IfSAR Quality Assurance (QA) Report

QA Report for Intermap Cells 393, 394, 398,
399, 400, 401, 402, 403, 404, 405, 406, 407,
408, 409, 410, 411, 412, 414, 415, 416, 417,
418, 419, 420, and 421

Produced for U.S. Geologic Survey

Report Date: May 15, 2020

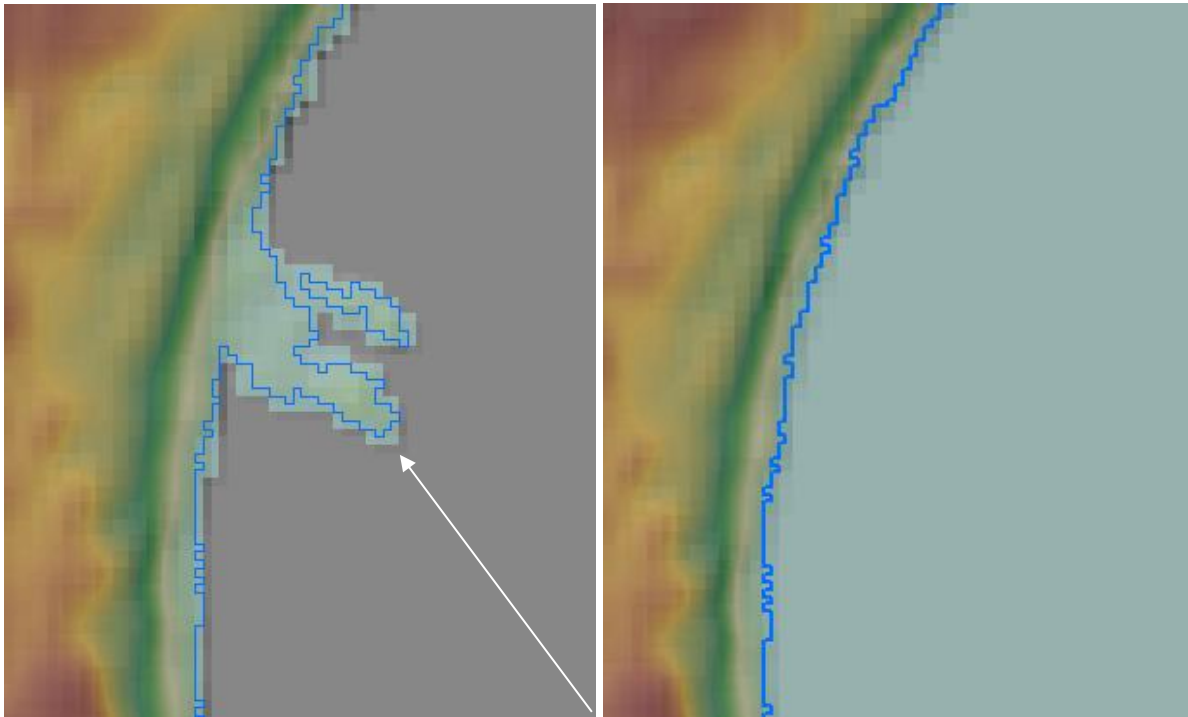
Piers, docks, and bridges should be fully modeled in the DSMs, but hydro-flattened in the DTMs. The hydro mask should match the DTMs to represent all areas hydro-flattened in the DTMs. Seven (7) areas were identified in the first delivery where docks or piers were either not modeled properly in the DSMs or were included in the hydro mask, causing the feature to not be flattened or modeled properly in the corresponding DTM and DSM. The piers were included in the hydro mask (flattened in the DTMs) and modeled properly in the DSMs by Intermap in the second delivery. Examples are shown below.

Figure 7 - Tiles N5245E17315P and N5245E17300P from cell 399. The DTM from the first delivery is shown on the left while the corrected DTM from the second delivery is shown on the right. Intermap hydro-flattened these piers/docks in the DTM and updated the hydro mask (blue) to reflect areas of the DTM that were hydro-flattened.

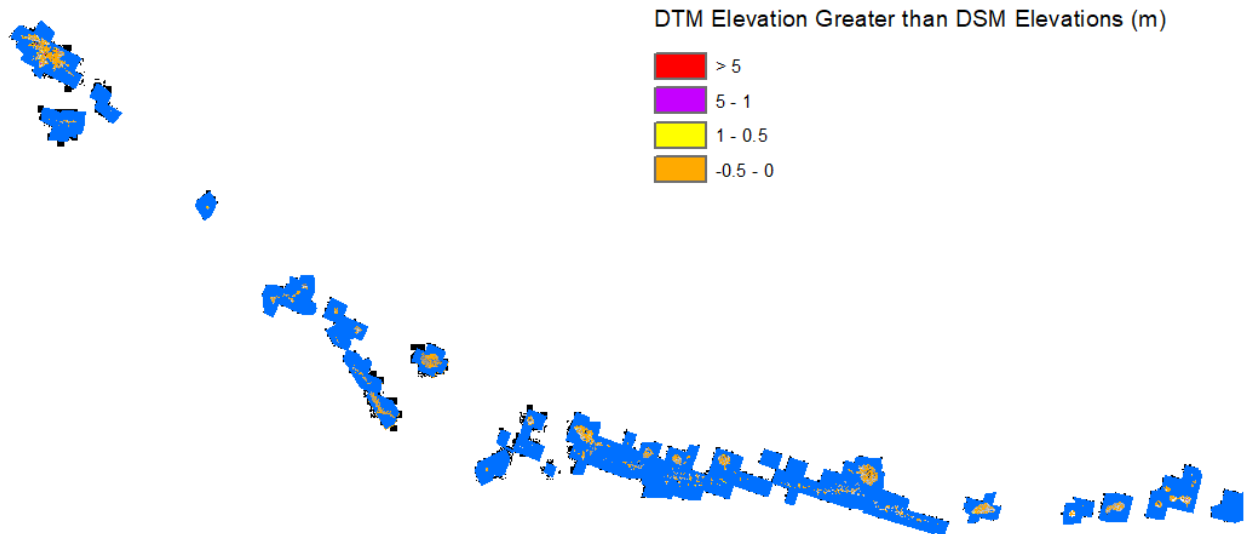
For the Western Aleutians Lot 7 (393, 394, 398, 399, 400, 401, 402, 403, 404, 405, 406, 407, 408, 409, 410, 411, 412, 414, 415, 416, 417, 418, 419, 420, and 421), Dewberry subtracted the DTM surface from the DSM surface. There are locations across the cells where DTM elevations are slightly higher than the DSM elevations. However, the overwhelming majority of locations where the DTM is higher than the DSM have differences less than 50 cm (see image below). Additionally, while speckled throughout the cells, the areas of higher DTM elevations are not contiguous and represent Intermap’s explanation of undulating radar noise. The few locations where DTM elevations are higher than DSM elevations by more than 50 cm generally occur in

very steep terrain, in interpolated areas identified by the void mask, and along steep hydrographic embankments.

Figure 9 - DSM/DTM difference raster for Western Aleutians Lot 7 cells 393, 394, 398, 399, 400, 401, 402, 403, 404, 405, 406, 407, 408, 409, 410, 411, 412, 414, 415, 416, 417, 418, 419, 420, and 421 is overlaid on ORIs, showing locations where the DTM elevations are higher than DSM elevations at the same xy location (5 m raster pixel). There are locations speckled throughout these cells where DTM elevations are higher than DSM elevations; this is a known and expected phenomenon with this IfSAR technology. The vast majority of areas where the DTM is higher in elevation than the DSM are by 50 cm or less.

Figure 10 – Tiles N5130E17845P and N5130E17830P from cell 415. The ORI from the first delivery appeared shifted relative to the hydro mask (left image). This area was reviewed by Intermap and reprocessed to correct the shift for the second delivery.

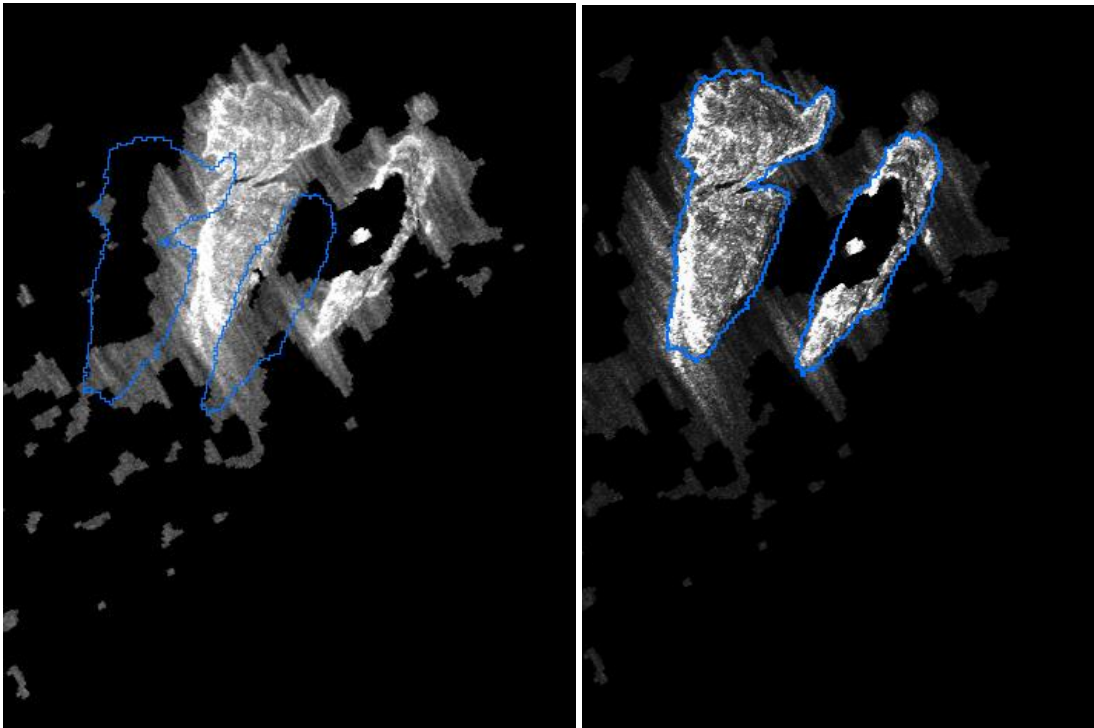
One (1) issue was identified in the first delivery where the ORI appeared shifted relative to the hydro mask. Intermap reviewed the area and determined that the shift was caused by an error in the ORI data. The affected ORIs were reprocessed for the second delivery and the shift was corrected. An example is shown below.

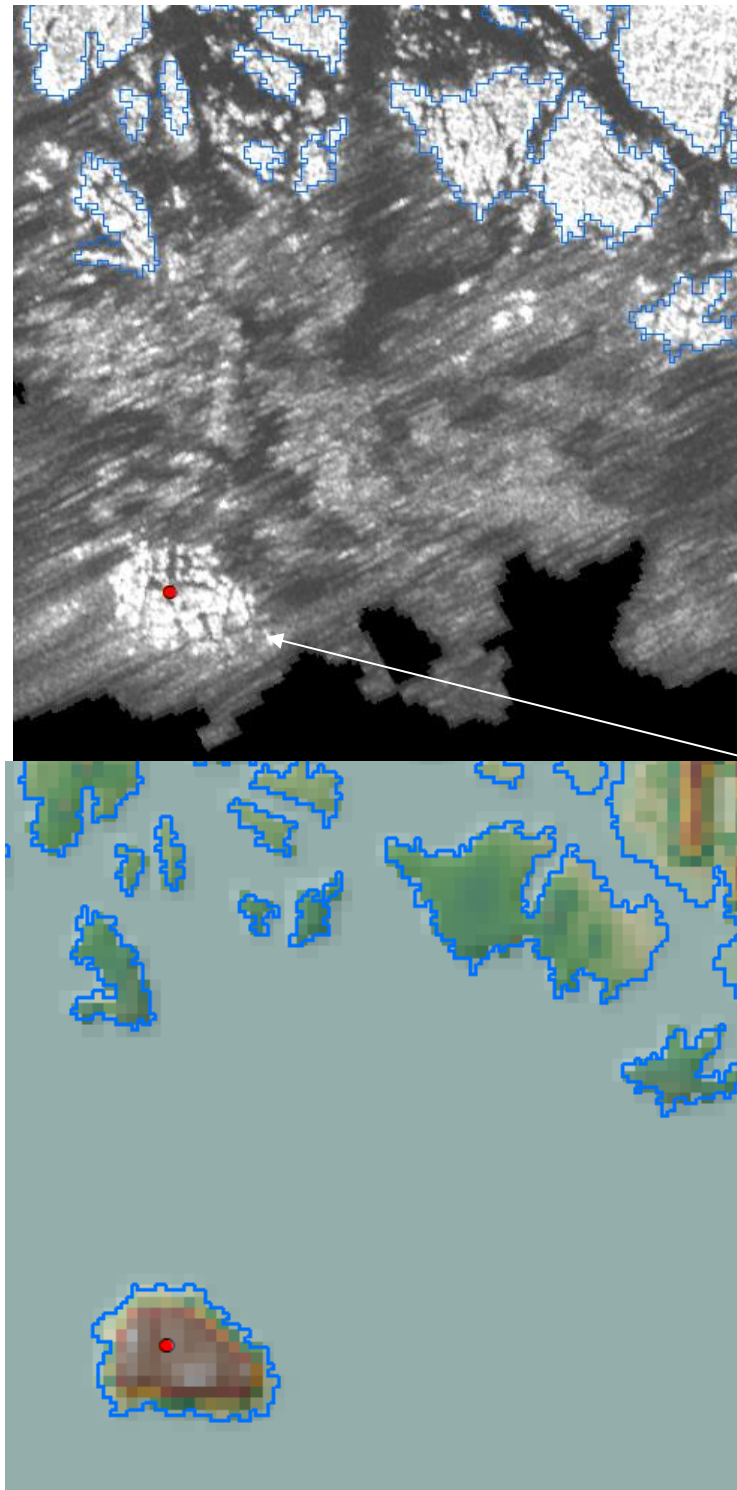
Twenty-four (24) areas were identified in the first delivery that required further investigation by Intermap to determine if valid land features were included in the hydro mask and flattened in the DTMs/DSMs. An example is shown below.

Figure 11 – Tile N5115w17915P from cell 417. Valid land features were included in the hydro mask and flattened in the DTMs/DSM in the first delivery (top image). Intermap excluded these land features from the hydro mask and modeled them properly in the DTM and DSM in the second delivery (bottom image).

Figure 12 – Tiles N5115E17915P and N5115E17900P from cell 416. In the first delivery, small islands were collected in the hydro mask that required further verification to determine if there was valid

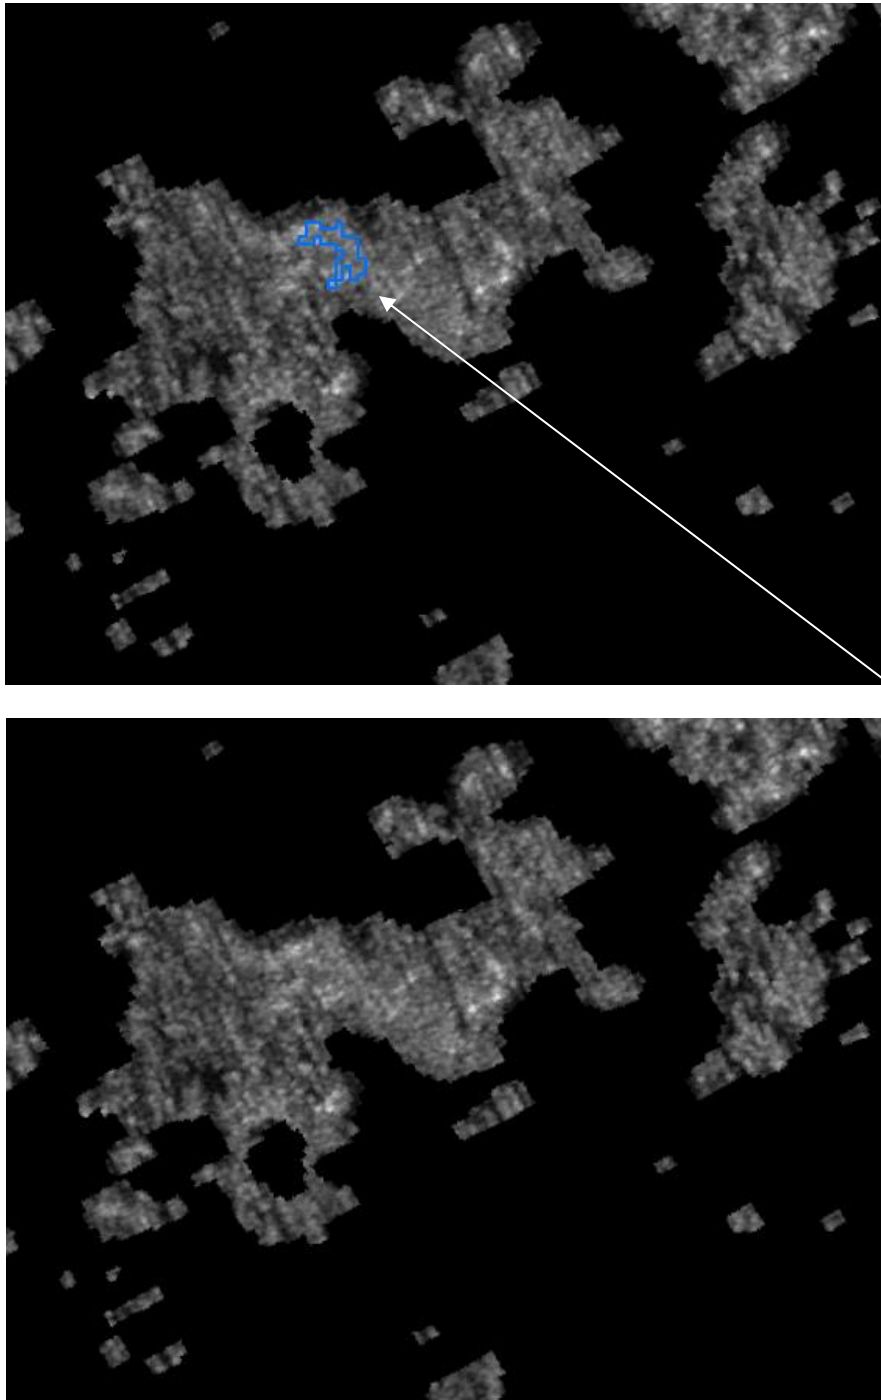
Four (4) issues were identified where small islands collected in the hydro mask required further verification. These features show no valid land in the corresponding ORIs. Intermap reviewed the features and found no valid land. The hydro mask, DTMs, and DSMs were adjusted in the second delivery to address the small polygons. An example is shown below.

land in these locations (top image). Intermap determined the small islands were not valid and the hydro mask was adjusted in the second delivery (bottom image).
